RE: Verhoeff Gravel Pit #1, File No. M-2014-025, Technical Revision (TR-1), Adequacy Review #1

The Division of Reclamation, Mining and Safety (Division) has completed its adequacy review #1 of your Technical Revision (TR-1) submitted for the Verhoeff Gravel Pit #1 located in Bent County. TR-1 was called complete on April 7, 2025. The decision date for TR-1 is currently set for May 7, 2025.

EXHIBIT C-3

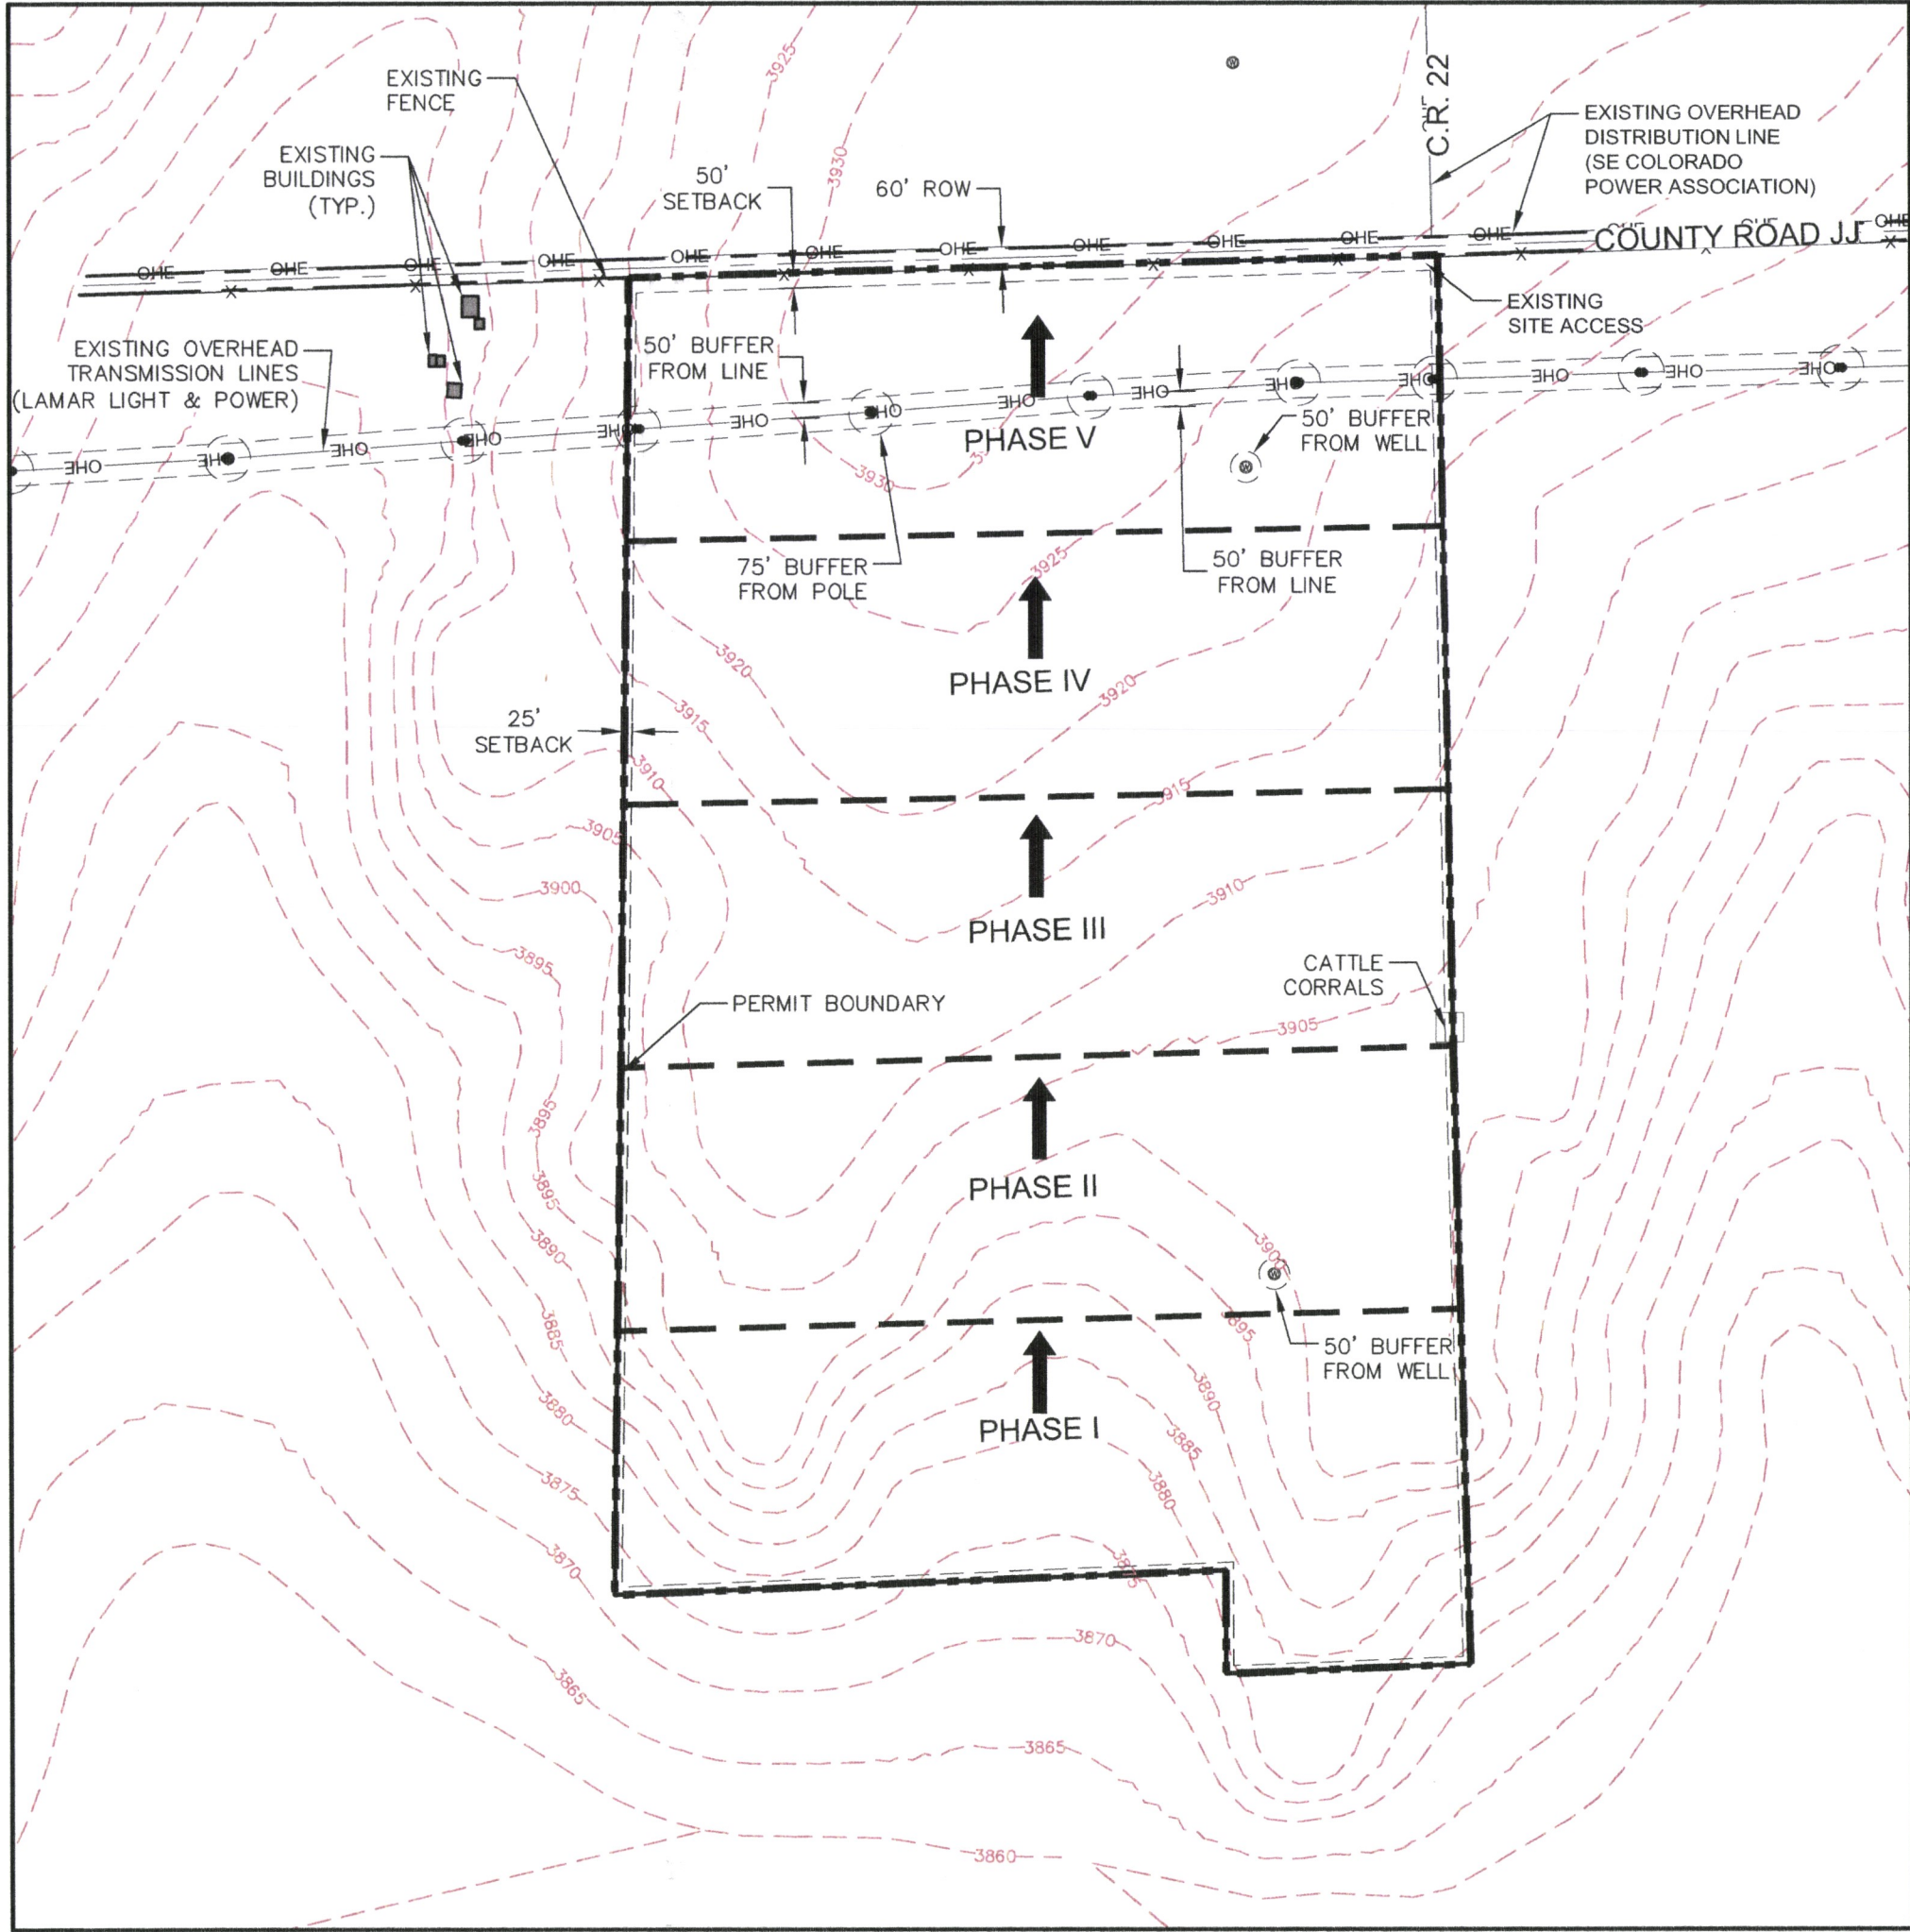
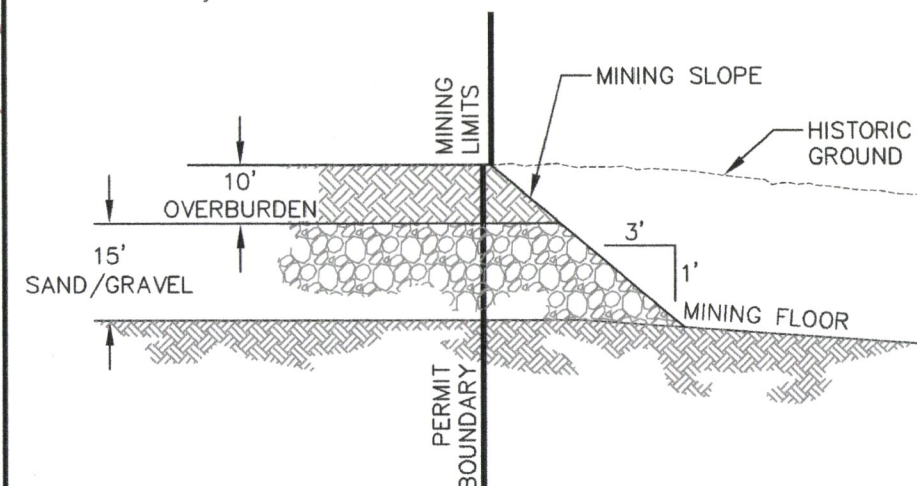
- 1) Please provide an updated Mining Plan Map (current approved map enclosed) that includes the following:
 - a) All general map requirements of Rule 6.2.1(2):
 - i. show name of the operator;
 - ii. is prepared and signed by a registered land surveyor, professional engineer, or other qualified person;
 - iii. give date prepared;
 - iv. identify and outline the area which corresponds with the application;
 - v. shall be prepared at a scale that is appropriate to clearly show all elements that are required to be delineated by the Act and Rules, not larger than 1 inch = 50 feet nor smaller than 1 inch = 660 feet;
 - vi. include a map scale, appropriate legend (identifying the permit boundary and all other map features), map title (Exhibit C – Mining Plan Map), date, and a north arrow.
 - b) Additional items:

- i. The location(s) of any topsoil stockpiles for each proposed phase.
- ii. The location(s) for material stockpiling for each proposed phase.
- iii. The location(s) of any fuel/oil storage for each proposed phase.

- iv. The location(s) of any water management structures, including sediment ponds, sumps, ditches, culverts, and discharge locations required for the operation for each proposed phase.

- v. The acreage of the proposed mining area for each proposed phase. (Note the map submitted shows Phase 1 = 120 acres and Phase 5 = 139 acres, which add up to a total of 259 acres; this exceeds the approved 250-acre permit area. Also, phase 5 appears to be an error, as there are only 2 phases proposed.)

- vi. The direction of mining.
- vii. Any proposed mining setbacks from existing structures and/or the permit boundaries. (Note, the current approved mining plan map shows 50-foot buffers from two wells located on the affected lands, a 75-foot buffer from a utility line that crosses the affected lands, 25-foot setbacks from the eastern, western, and southern permit boundaries, and a 50-foot setback from the county road. If the operator is proposing new setbacks, please ensure any agreement with the applicable structure owner(s) reflects this change.

- viii. The name of the existing access road (County Road JJ).

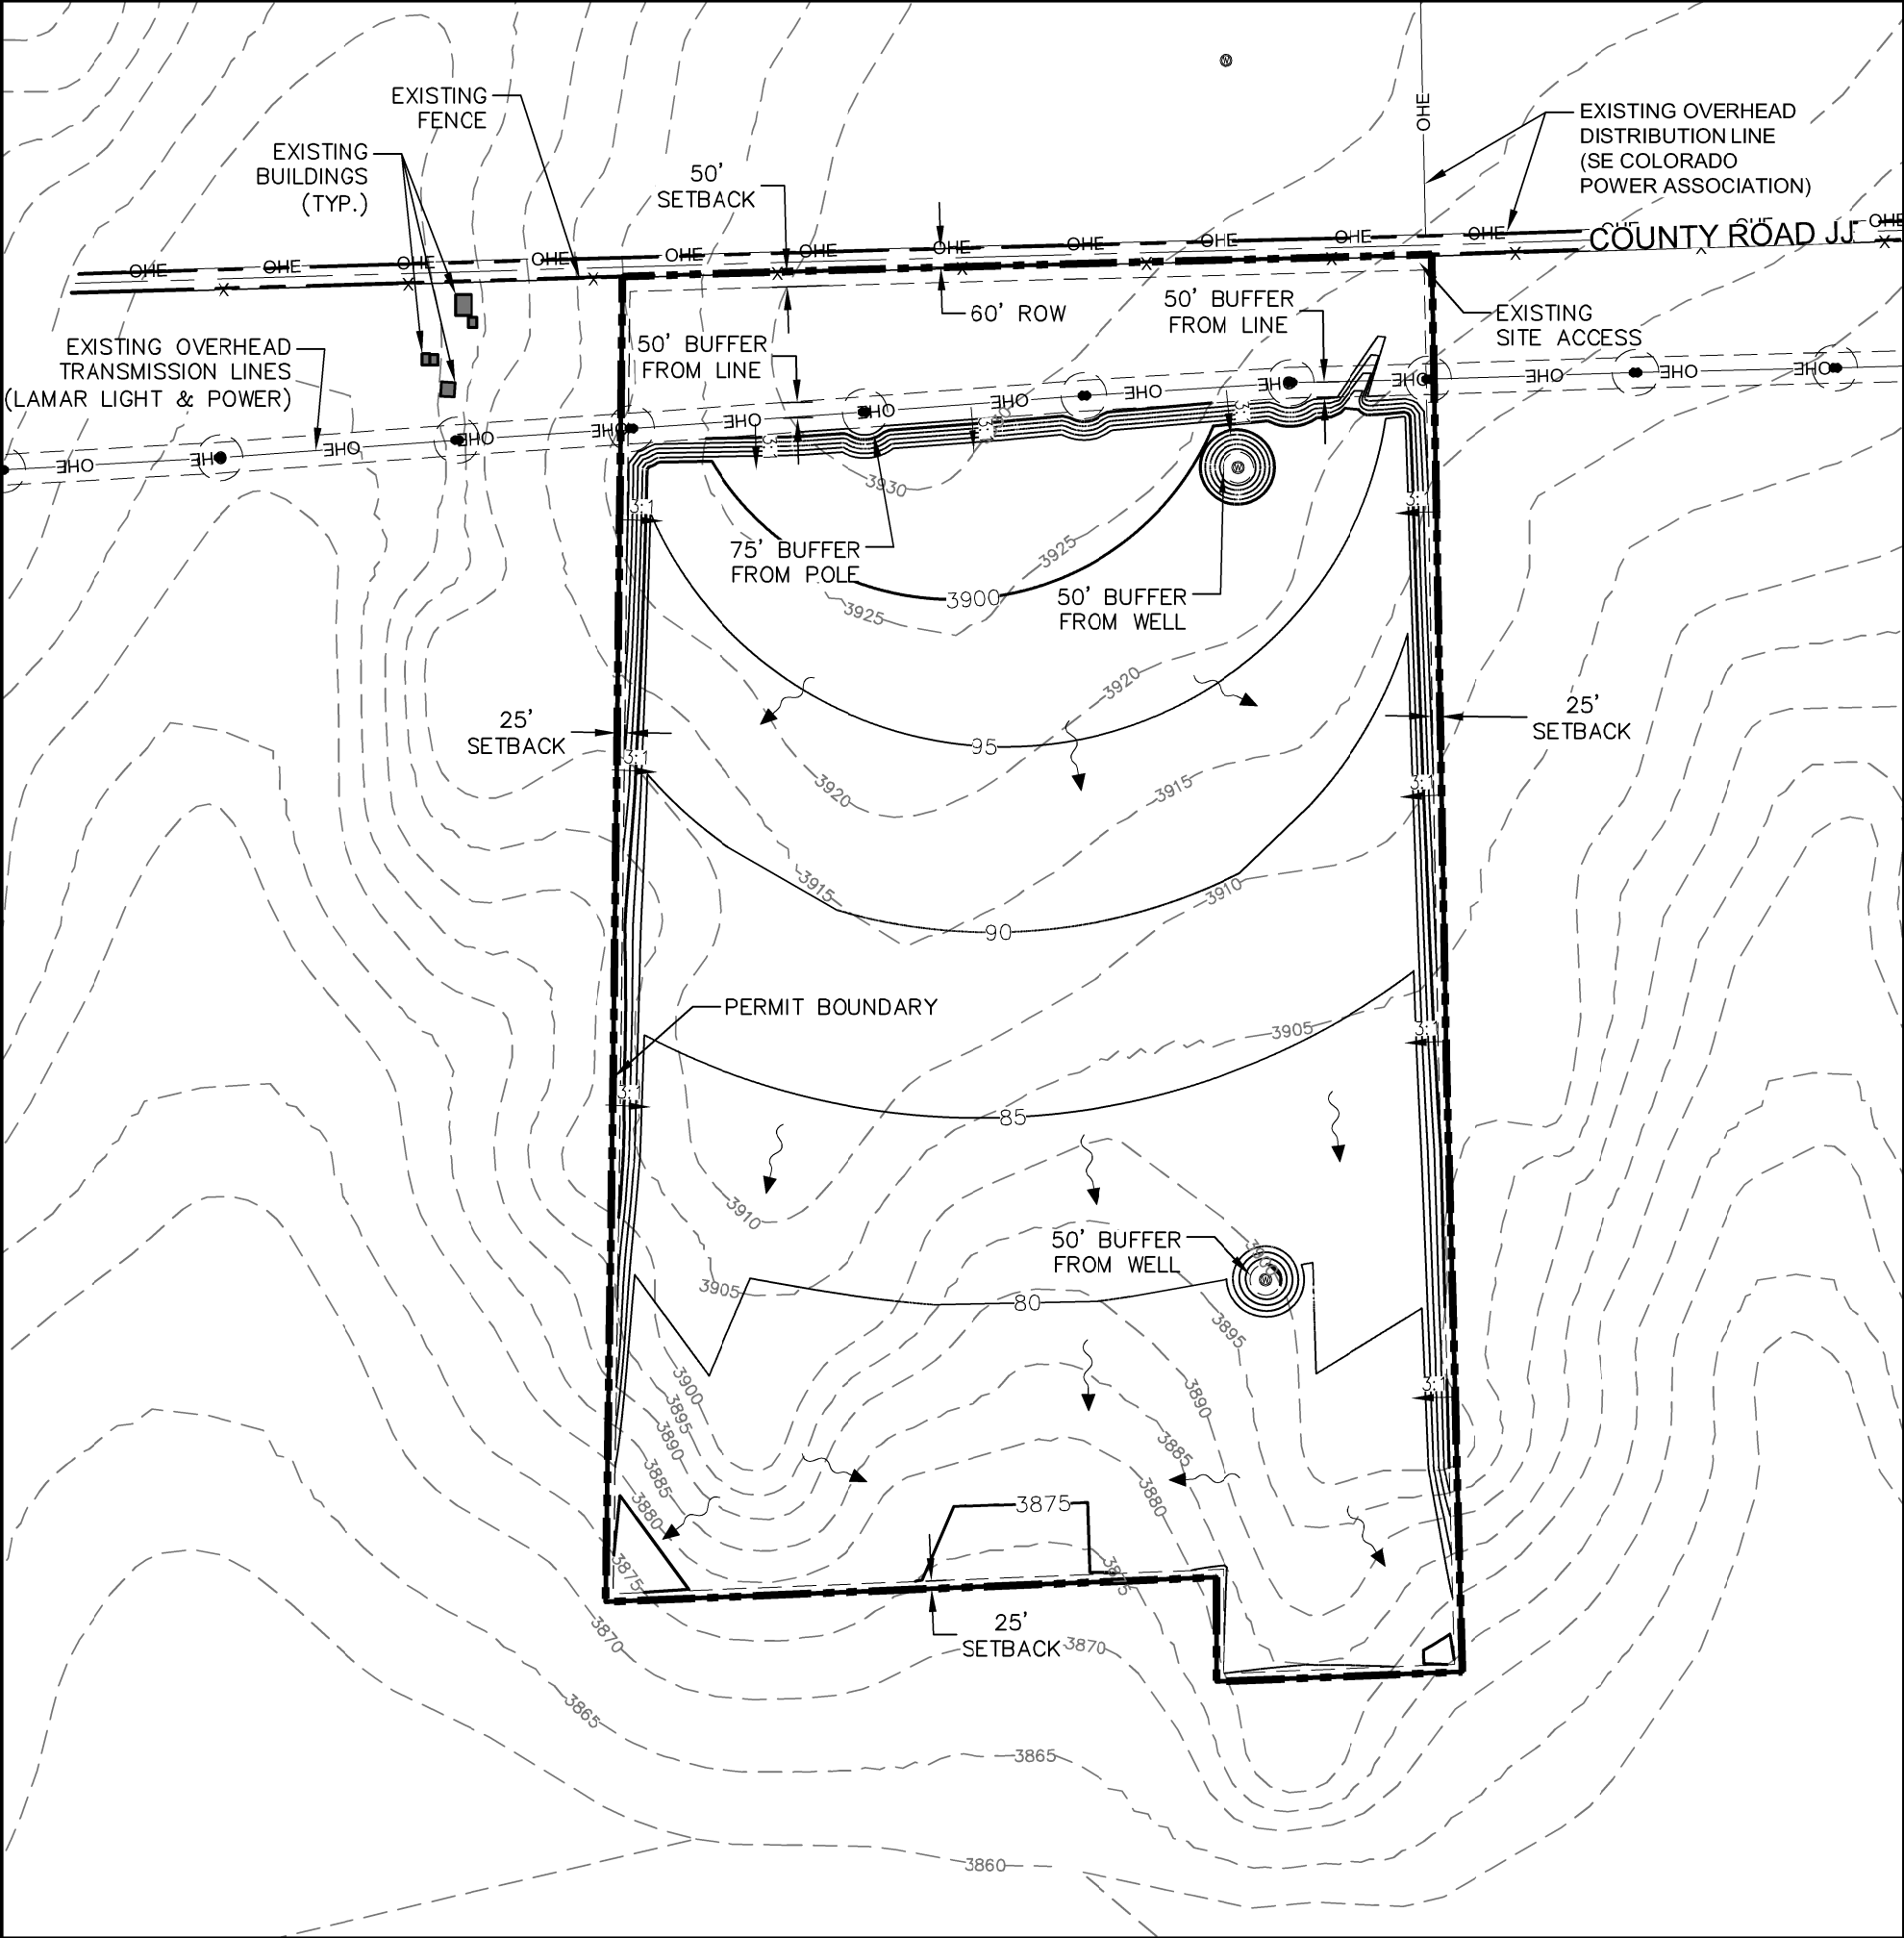
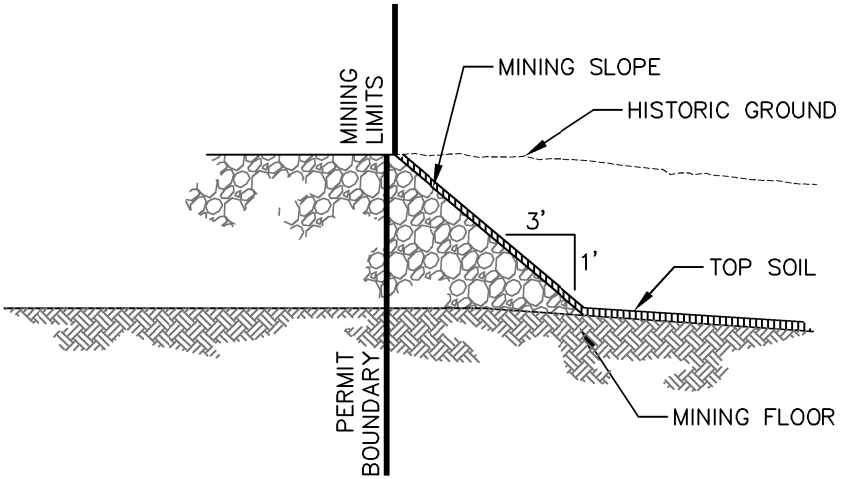
- 4) Please clarify if the proposals in TR-1 will in any way change the approved reclamation plan map (enclosed). If so, please provide a revised reclamation plan map. [Note the current approved reclamation plan map shows the northern edge of the permit area will not be mined and several buffers will be maintained from structures located within the affected lands (e.g., wells, utility line). If the operator is proposing anything different from what is shown on the current approved map, a new reclamation plan map must be submitted.]
